CALIFORNIA COASTAL COMMISSION

**TU 9d****STAFF REPORT: REGULAR CALENDAR****APPLICATION NO.:** 5-01-080**APPLICANTS:** Sal Palmero**AGENT:** William Peters, Cook/Peters Associates**PROJECT LOCATION:** 3317 Ocean Boulevard, City of Newport Beach,
County of Orange

PROJECT DESCRIPTION: Construct a pool house, pool, spa and exercise room on a lower portion of the bluff face down to the toe of the bluff. Construction also includes retaining walls, fences, a BBQ, trellis, iron gate, glass railing, drainline, concrete paving, steps, including the repair and modification of the existing stairs. A total of 120 cubic yards of grading will take place. Grading will consist of 60 cubic yards of cut and 60 cubic yards of fill. Footings, slab on grade and a caisson foundation system will support the proposed structures.

SITE PLAN

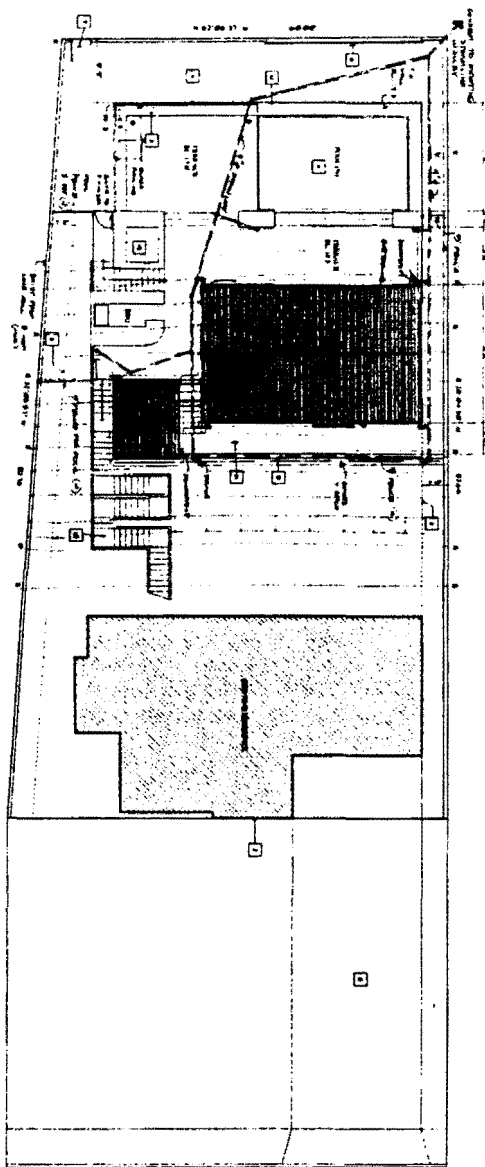
The applicant is proposing to construct a pool house, pool, spa and exercise room on a lower portion of the bluff face down to the toe of the bluff. Construction also includes retaining walls, fences, a BBQ, trellis, iron gate, glass railing, drainline, concrete paving, steps, including the repair and modification of the existing stairs. Two retaining walls are proposed, one located along the western perimeter of the swimming pool and the other (considered the "northeasterly" retaining wall) at the rear of the pool house immediately beneath the bluff (Exhibits #5-8). These walls will vary from approximately 6 to 12 feet in height. The approximately 6 foot high retaining wall located along the western perimeter of the swimming pool will raise the proposed pad elevation to approximately 17 feet above mean sea level (6 feet above grade) in order to support the above ground swimming pool. Also, an approximately 5 foot high fence will be located at the

The existing home is located at the top of the bluff and is not part of the proposed project, therefore application of the structural stringline is unnecessary. Additionally, the homes adjacent to the northwest and southeast do not appear to have any decks which precludes establishment of a deck stringline. Also, the structure located at the toe of the bluff to the adjacent northwest appears to be unpermitted development that the Commission's Enforcement Staff is currently investigating. In addition, at the toe of the bluff to the southeast is unpermitted development. Unpermitted development cannot be used in order to conduct a proper stringline analysis. Therefore, the deck stringline cannot be applied with this project.

CROSS SECTION A - A'

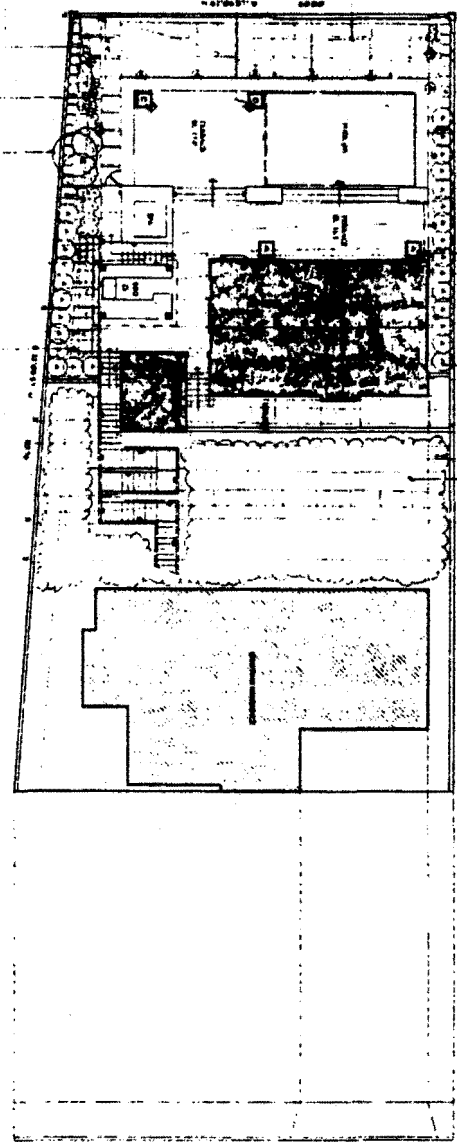
A total of 120 cubic yards of grading will take place. Grading will consist of 60 cubic yards of cut and 60 cubic yards of fill. This will be accomplished by grading the lower portion of the bluff and

the toe of the bluff. The cut will be used as backfill to establish a building pad for the pool and associated hardscape (Exhibit #6, page 2 of 2).

The Coastal Act also requires new development to be sited to "*minimize the alteration of natural land forms.*" The *Geotechnical Investigation* indicates that the proposed project would be located on a lower portion of the bluff face down to the toe of the bluff. The existing bluff is a natural landform visible from public vantage points such as the beach (Corona Del Mar State Beach) and Inspiration Point. Any alteration of this landform would affect the scenic views of the coastline when viewed from the State Beach and Inspiration Point. Also, the proposed project would have an adverse visual impact because instead of a natural vegetated bluff seen on the bluff face from the beach, an approximately 6 foot high retaining wall and an approximately 5 foot high fence would be visible along the lower portion of the bluff and the toe of the bluff from the beach. As such, new development at the subject site must be appropriately sited to minimize adverse effects to existing scenic resources. Thus, the proposed project is inconsistent with Section 30251 of the Coastal Act regarding scenic resources.
